Modification to run CPU09CMI on 4.5MHz bus.

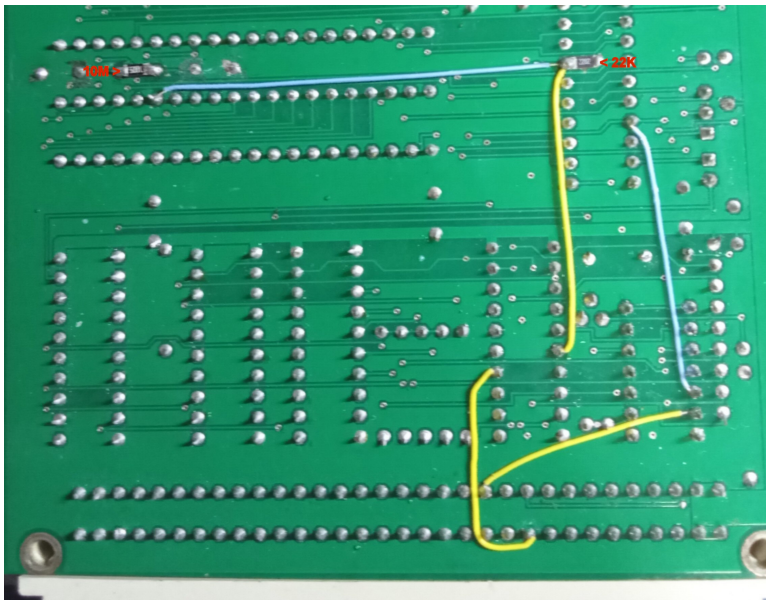
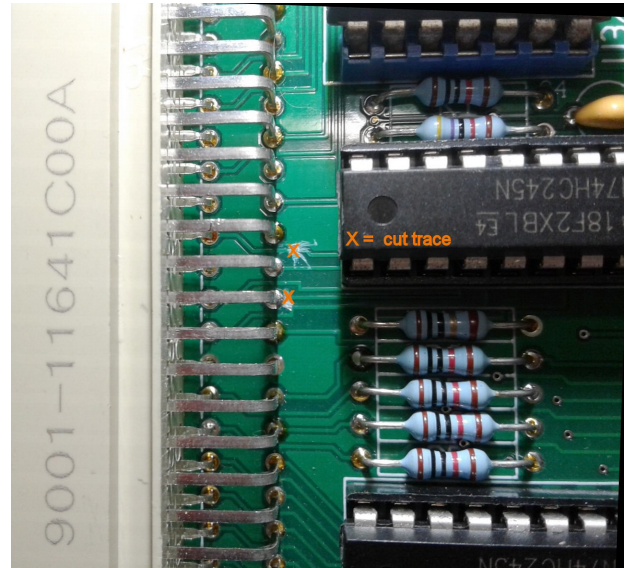
On top side:

Cut trace between U4-14 and J1 C-21 (B_VMA-)

For REV:0.9 print only cut trace from J1 A23 to R15

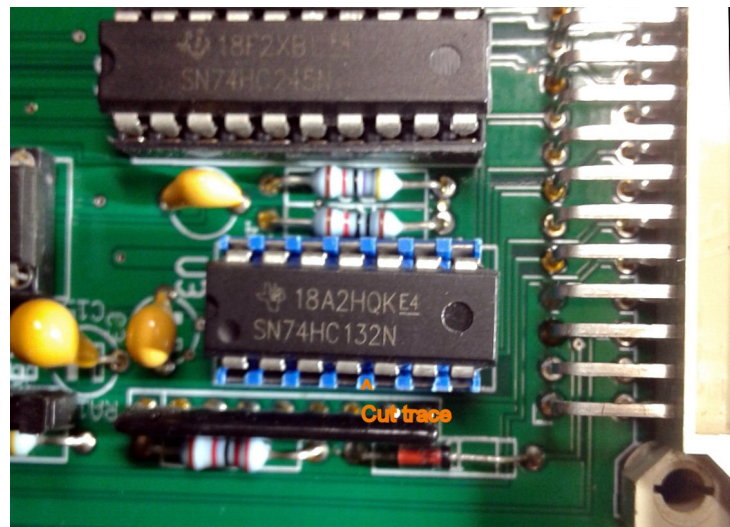
On solder side:

Cut trace between U13-19 and via (OVMA-)

Place 22K resistor between U13-19 and Gnd

Place wire from U6-35 to U13-19 (blue) and U4-6 (Q) (yellow)

Place wire from U4-14 to J1 A-23 (B_Q) (yellow)

Place wire from U3-7 to J1 C-21 (B_VMA-) , Or:
**To keep CPU09CMI 68x02 compatible
or need VMA- signal with 68x02 on the bus
for CPU09GPP or CPU09RAM card.**
